In the Matter of  
Wisconsin Electric Power Company  
(Point Beach Nuclear Plant, Unit 1)  
Docket No. 50-266 (OLA-2)

DOCKET NO. 30-266  
STEAM GENERATOR REPAIR  
POINT BEACH NUCLEAR PLANT, UNIT 1

LICENSEE'S RESPONSES TO QUESTIONS IN  
THE MARCH 22, 1983 APPEAL BOARD ORDER

Fig. 1. Illustration of major steps involved in full depth tube to tubesheet expansion process.

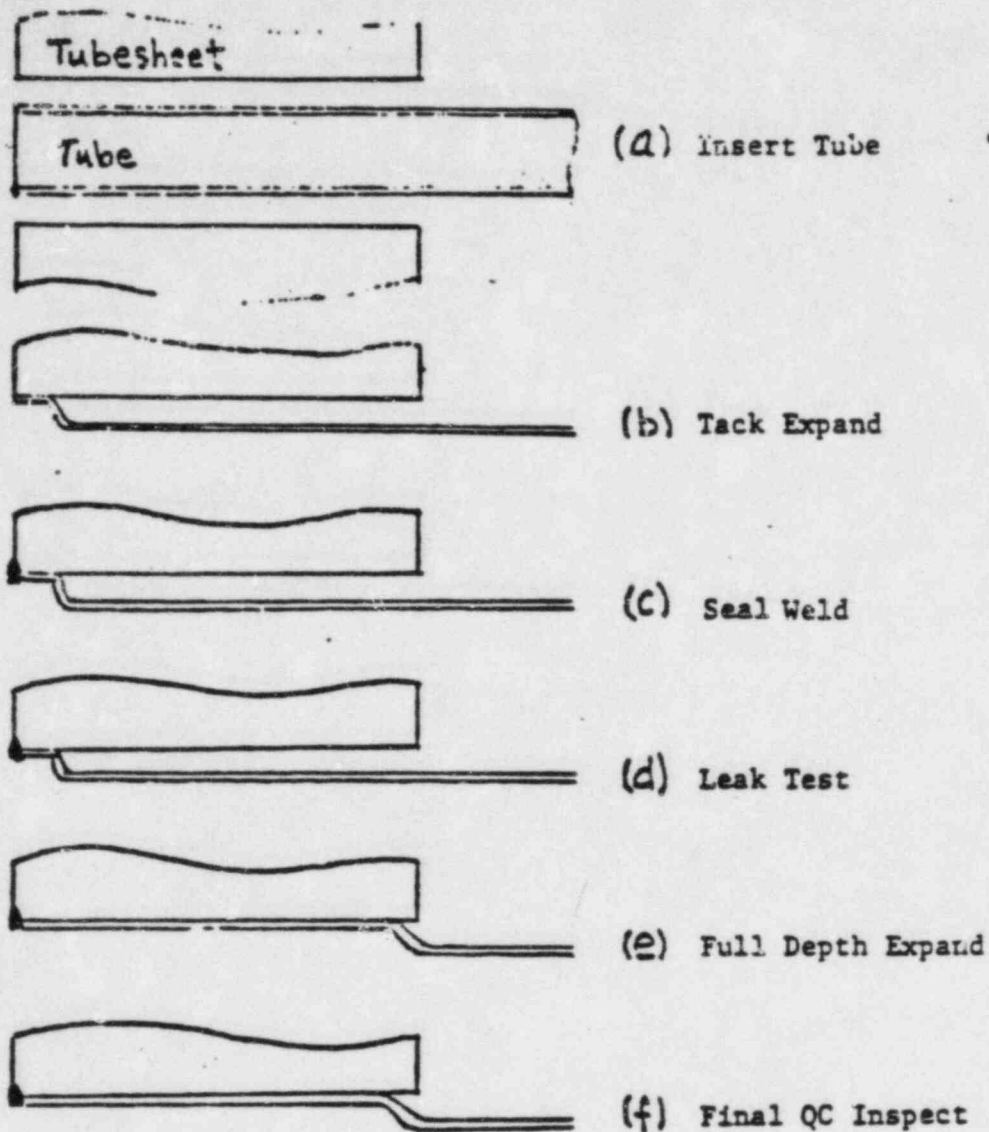
The main steps associated with each expansion process are depicted schematically in Fig. 1, and include:

Fig. 3. Hydraulic expansion transition zone profile schematic at top is at 13X magnification. Traces at bottom are actual radial profile traces from a recent production unit.

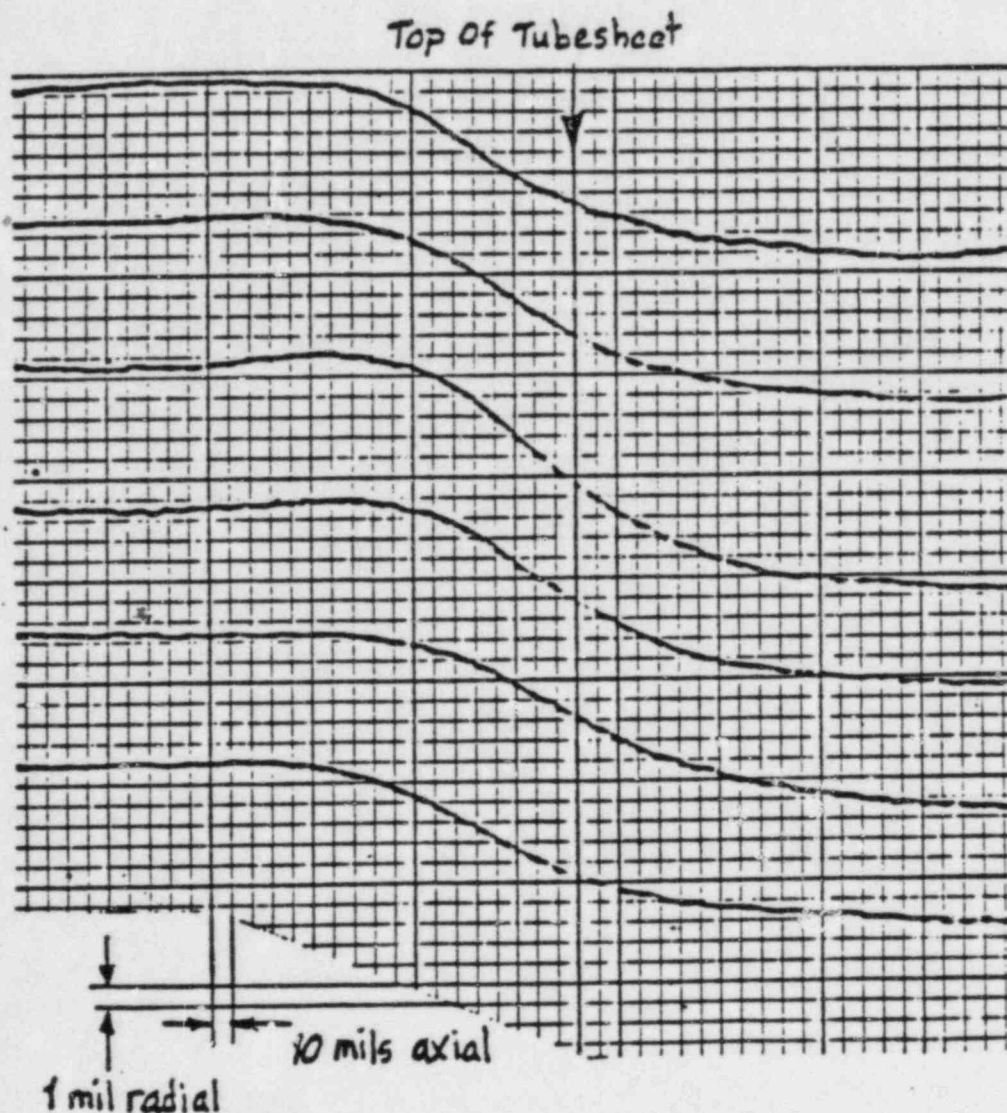
A typical hydraulic transition zone profile is shown in Fig. 3. The transition zone length is usually 0.25 to 0.3 inch long.

Fig. 4 Illustration of how residual stresses are determined by stress corroding cracking tests.

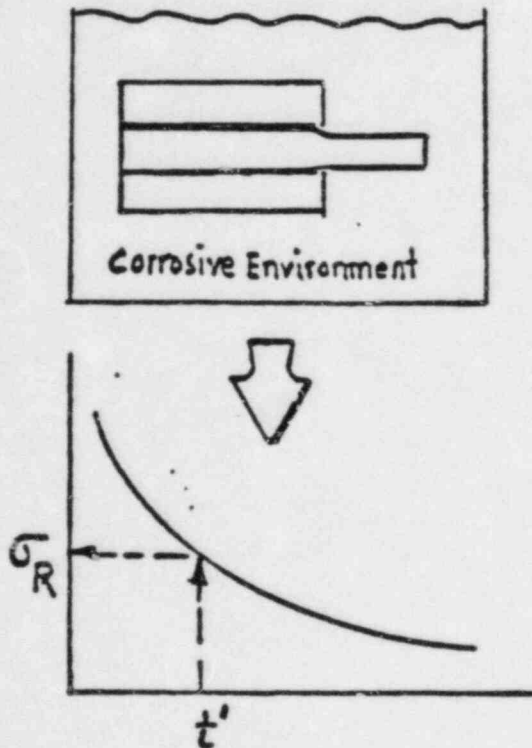
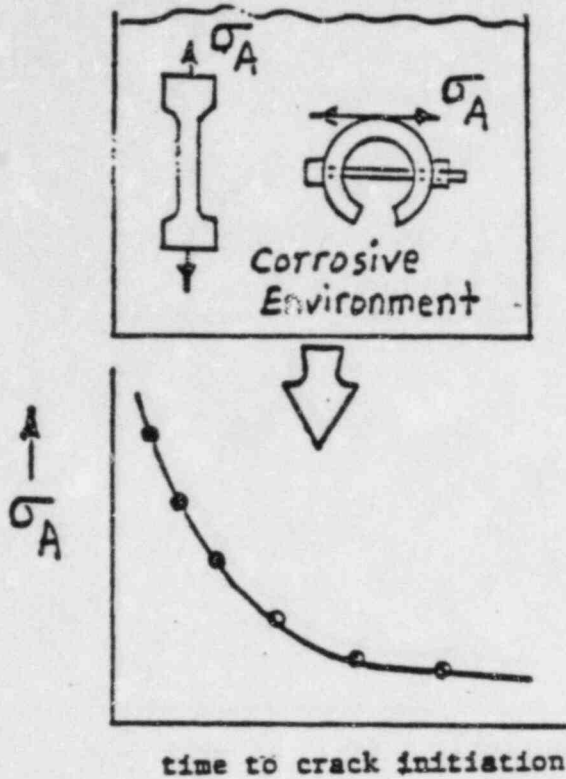
The test can be made quantitative by calibration. For this purpose, specimens of sensitized tubing are stressed to various known applied stress levels (no residual stresses) and tested in the corrosive environment as depicted in

Fig. 4. The specimens may be uniaxial tensile specimens but more often are C-ring specimens loaded to a given outer fiber stress. The results give a curve (called C-ring curve for C-ring specimens) of applied stress versus time to crack initiation. Samples having only residual stresses are then prepared and tested. Using the time to cracking, the C-ring or calibration curve is entered at that time to determine the magnitude of the residual stress as depicted in Fig. 4.

Fig. 5 Relative comparison of residual stresses for various expansion processes. Though stress and time scales are given to provide perspective, the figure is intended to be more schematic than quantitative.

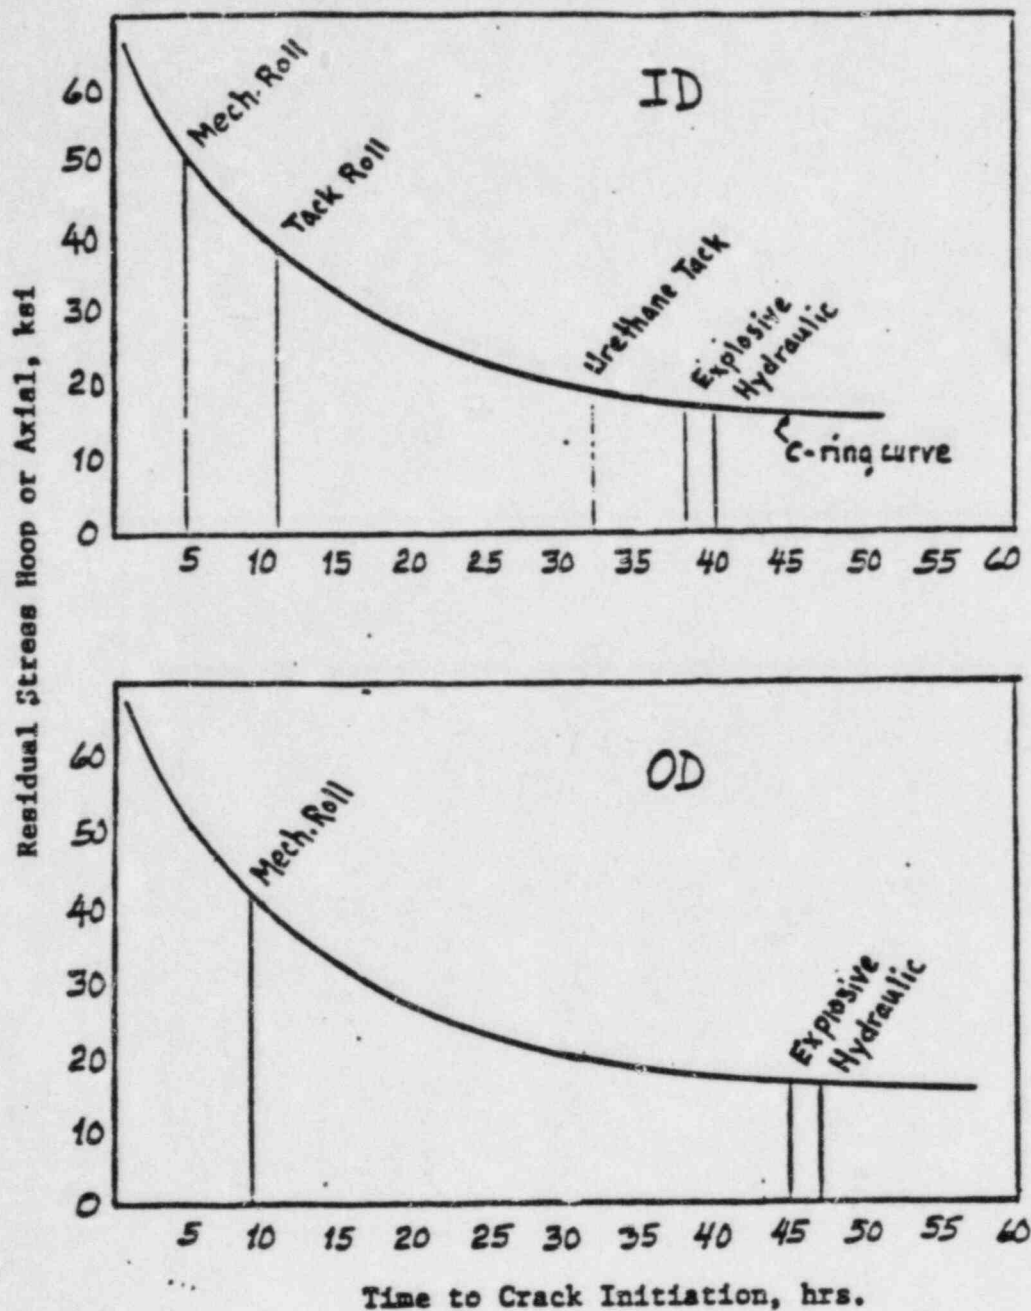
The residual stresses are somewhat higher on the ID than on the OD. The relative magnitude of the residual stresses for various expansion processes are compared in Fig. 5. The comparison uses polythionic acid test results and the C-ring curve but should be viewed only in a relative qualitative sense. The residual stresses in the transition zone are highest for hard (high torque) mechanical rolling and lowest for hydraulic expansion. Though the data are limited, the residual stresses for explosive expansion (called WEXTEx by Westinghouse, i.e., Westinghouse Explosive Tube Expansion) are low, similar to hydraulic expansion.
